Re: Geologic Hazard Additional Borings
Springs at Waterview East (Trails at Aspen Ridge)
South Powers and Bradley Road
Colorado Springs, Colorado

**APPENDIX A: Colorado Geological Survey Review Letter, dated
July 19, 2019, CGS Unique No. EP18-0011_5**

Subject: Trails at Aspen Ridge PUDSP191 (previously reviewed as Springs East at Waterview SP-17-010) El Paso County, CO; CGS Unique No. EP-18-0011 5

SITE PLAN/TEST BORING LOCATION MAP
SPRINGS AT WATERVIEW EAST
S POWERS BOULEVARD AND BRADLEY ROAD
EL PASO COUNTY, CO.
FOR: COLA, LLC

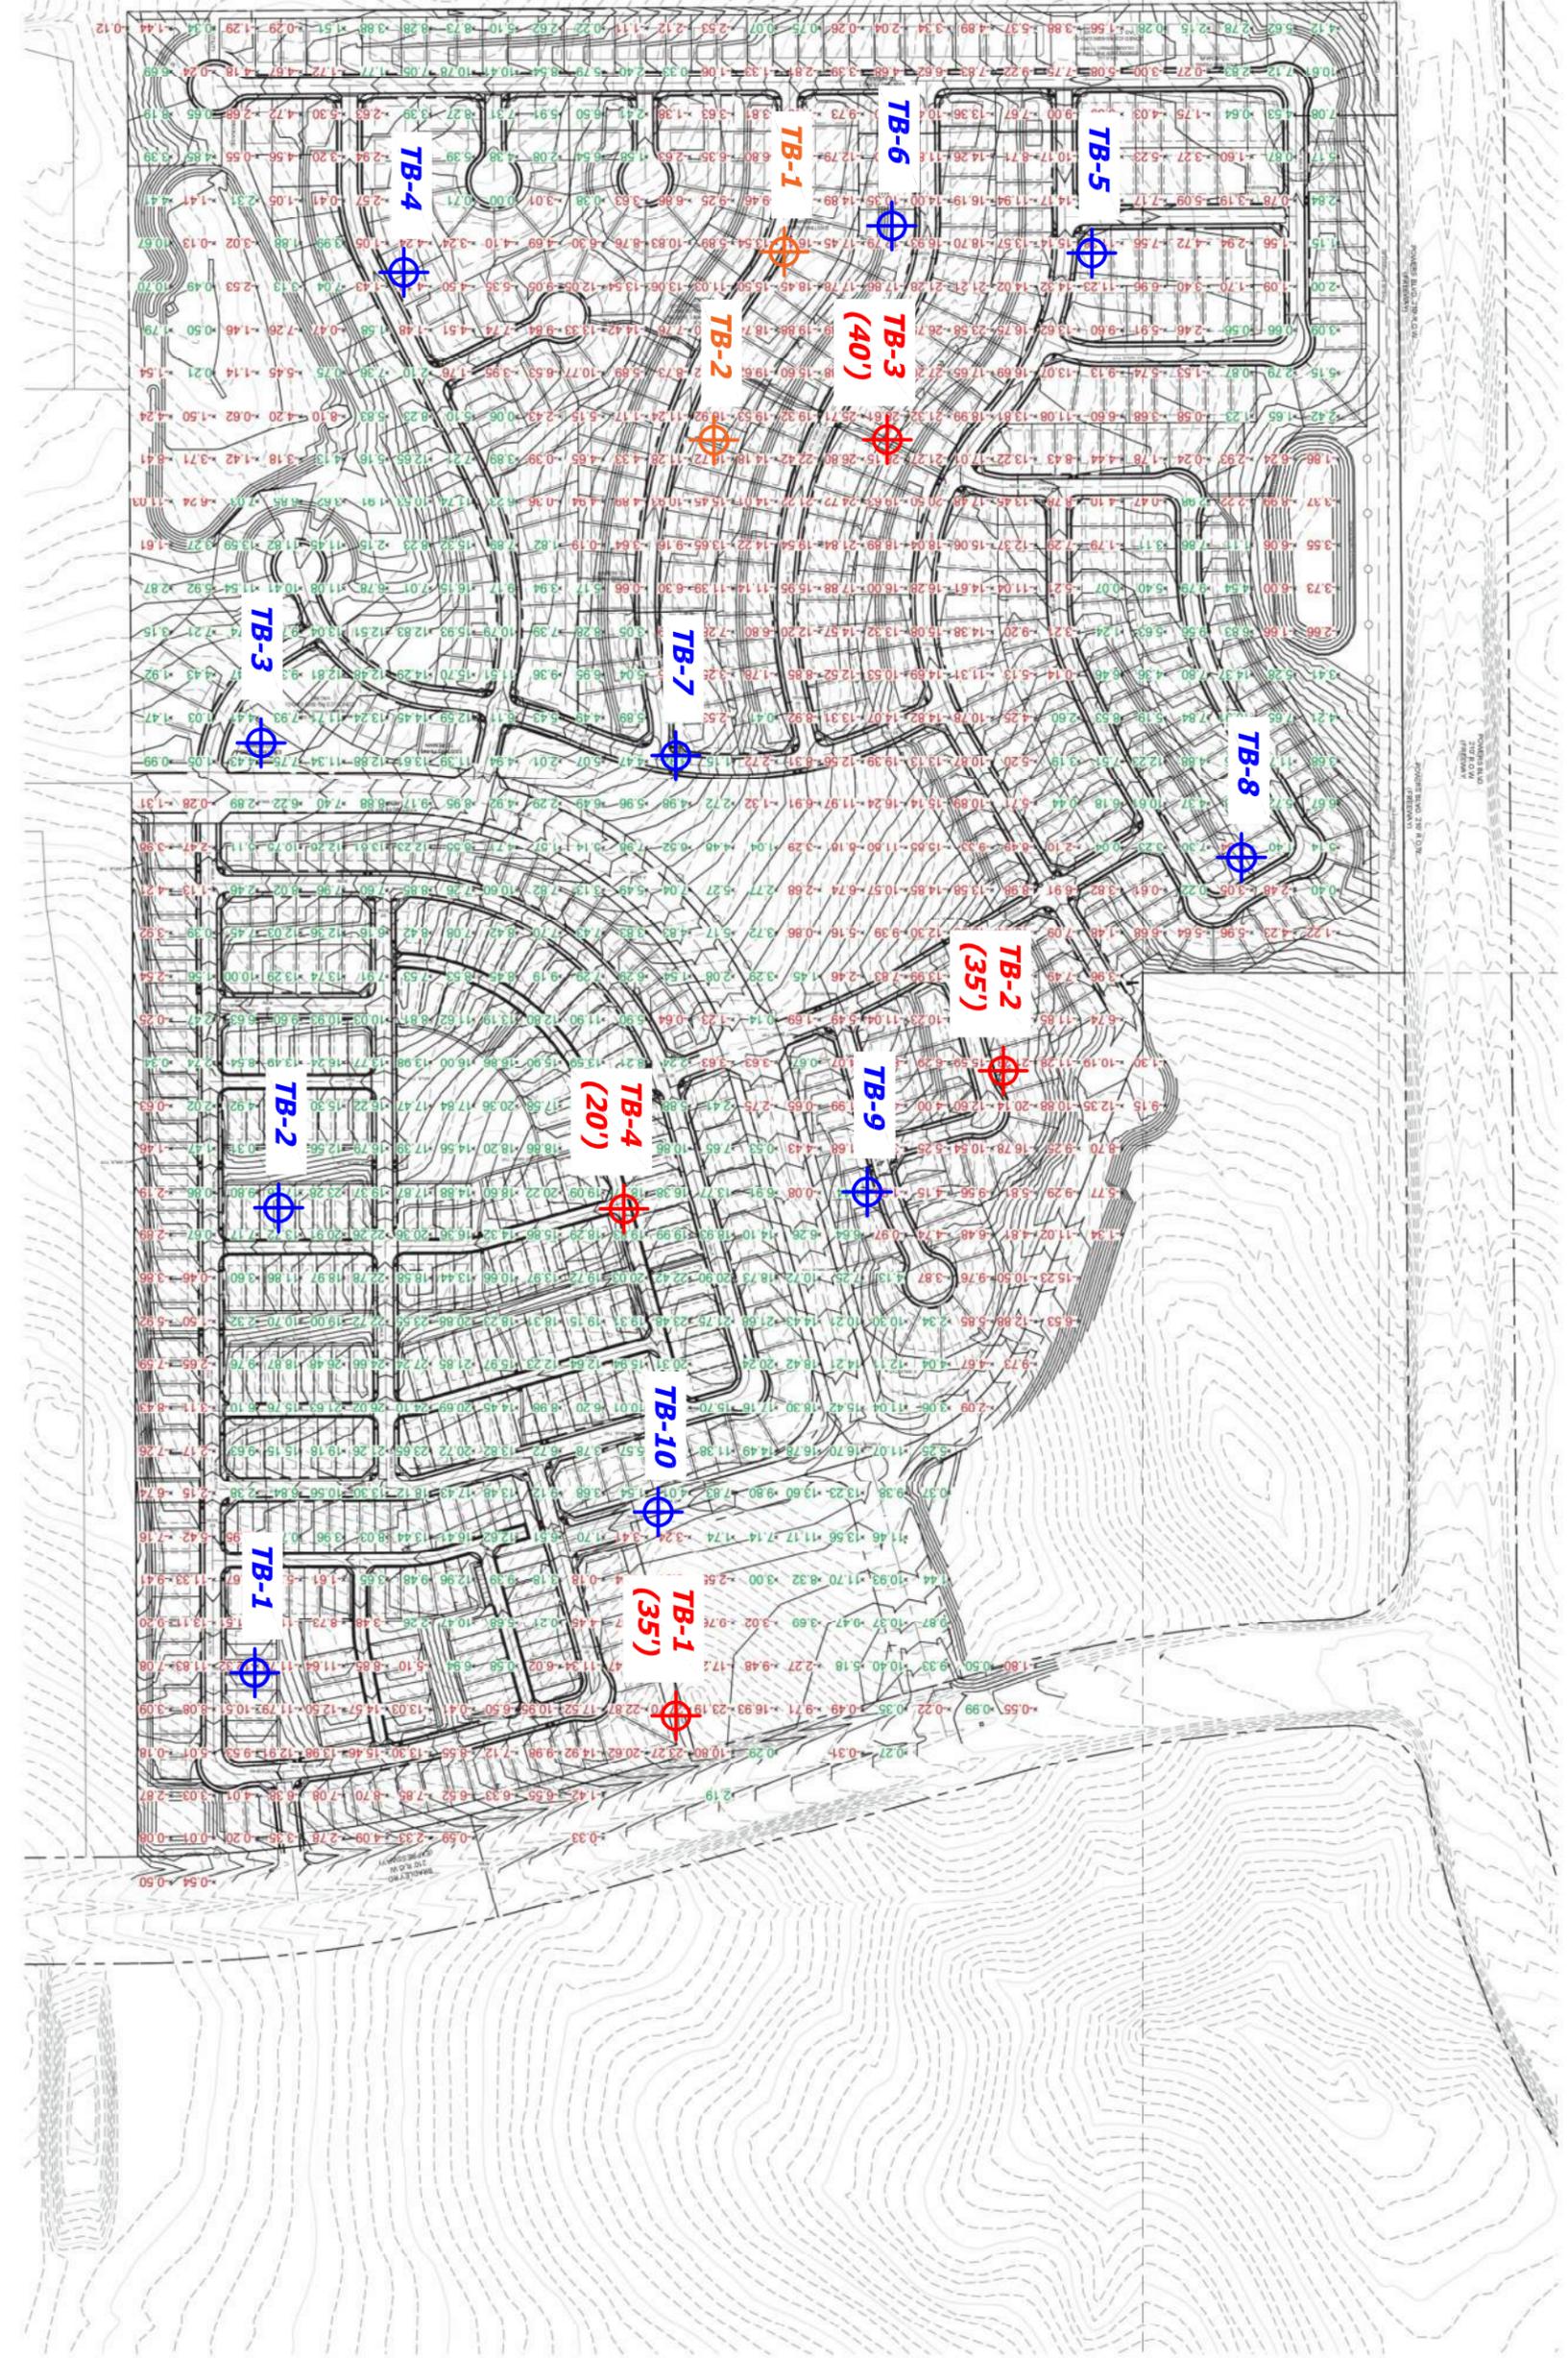
CGS previously discussed concerns about insufficient subsurface information in the northeastern and southwestern areas of the site, where significant cuts are planned. **The additional borings described by Entech in their 4/10/2019 addendum are not located within the areas of concern.**

Additional investigation, sampling, testing and analysis are needed in proposed areas of cuts exceeding about 8 feet, based on the project grading plans, to characterize subsurface conditions, determine depth and extent of overexcavation, if overexcavation is planned to reduce the use of drilled pier foundations, and to determine basement feasibility where Entech's borings did not extend to sufficient depth below planned basement floor and foundation bearing depths.

CGS recommended additional investigation on the site in areas where significant cuts are proposed. Entech drilled four additional borings on August 7, 2019. Test Boring locations are shown on Figure 1. Test Boring Nos. 1 – 3 were drilled in areas of deep cuts, and Test Boring No. 4 was placed in an area of significant fill. Groundwater was not encountered during drilling or subsequent to drilling. The test borings were drilled to depths of 20 to 40 feet. Soils encountered in these borings consisted of predominantly sandy clay soils with underlying claystone and shale bedrock. The bedrock underlying the site is the Pierre Shale Formation of Cretaceous Age, which typically has a moderate to high expansion potential.

The new borings do not alter the conclusions in the previous reports. Based on the additional subsurface information, it is anticipated claystone or shale will be exposed in the majority of cuts proposed on the site. These soils have the potential for moderate to high expansion potential. Mitigation of the expansive soils will be required for the majority of the site. Specific recommendations for foundations and construction will be provided in the Subsurface Soil Investigations after additional site investigation is performed for the different phases of the development prior to construction.

TEST BORING LOCATION MAP
TRAILS AT ASPEN RIDGE-BORROW SITE
EL PASO COUNTY, CO
FOR: COLA, LLC

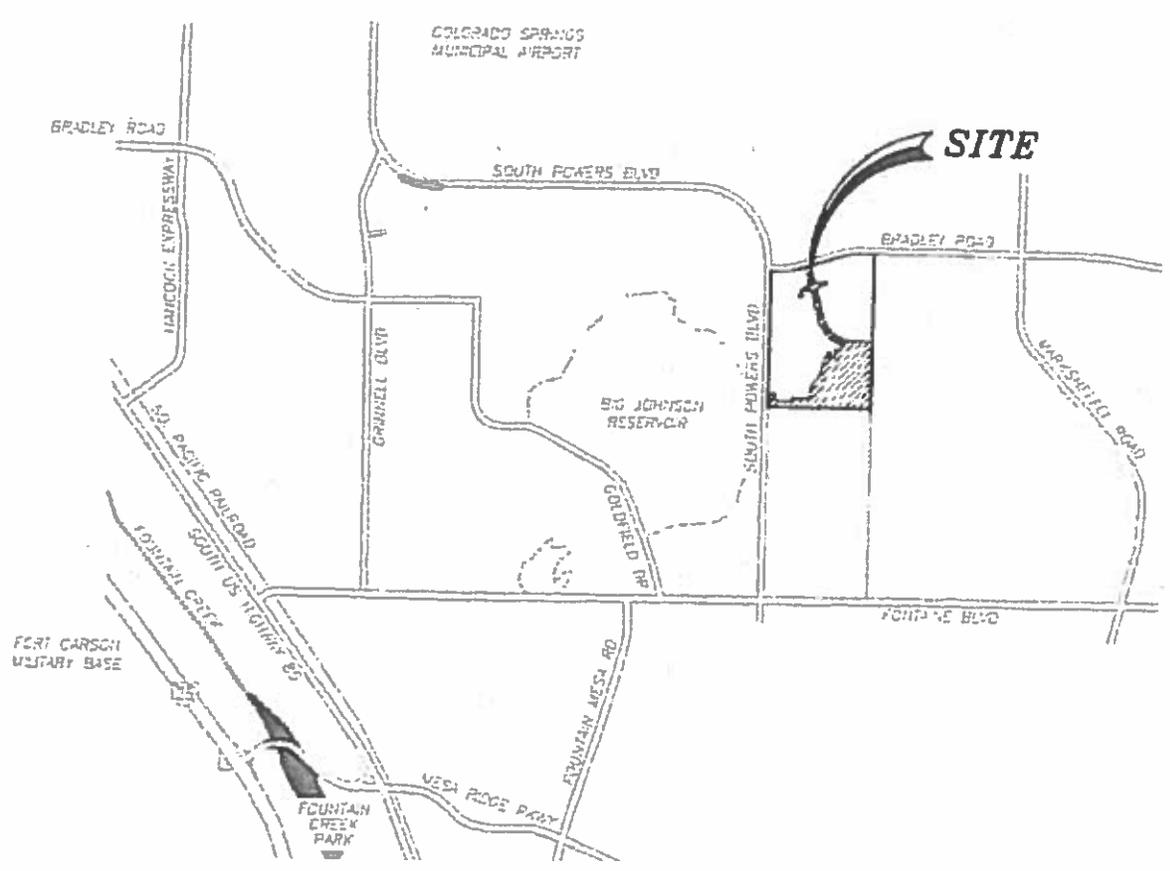
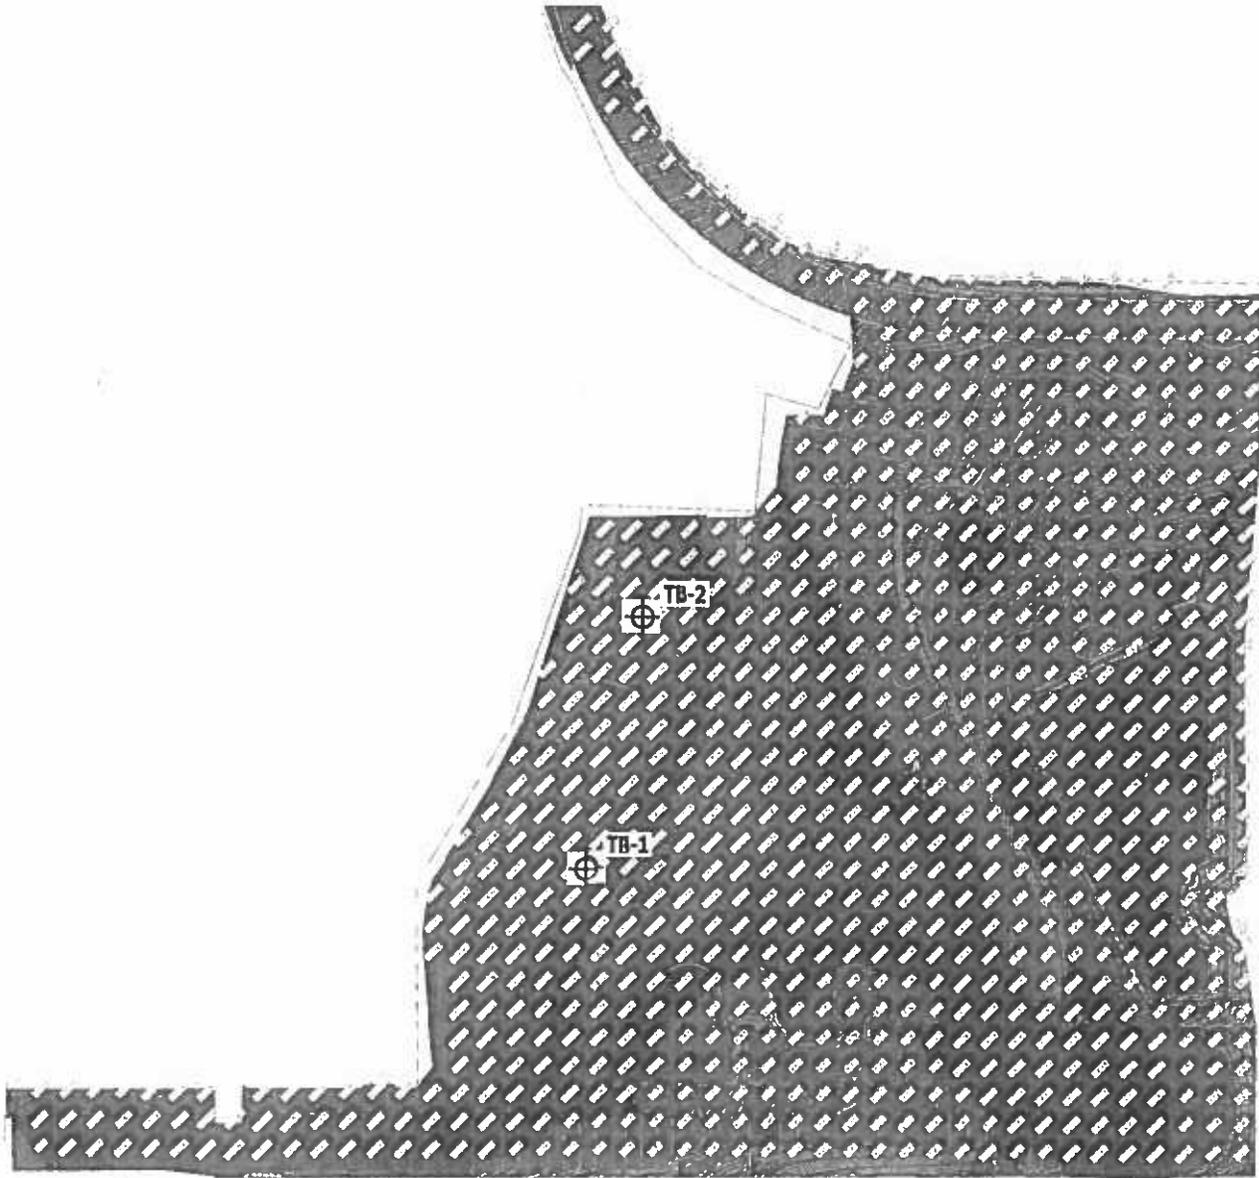
The locations of Entech's Appendix C borings are difficult to determine because of the poor quality of Figure 2, but appear to be located east of proposed Wagon Hammer Drive, outside of the currently proposed Trails at Aspen Ridge development area, within the existing Phase I (Not a Part)/Filing I Area To Remain identified on the PUD and grading plans.
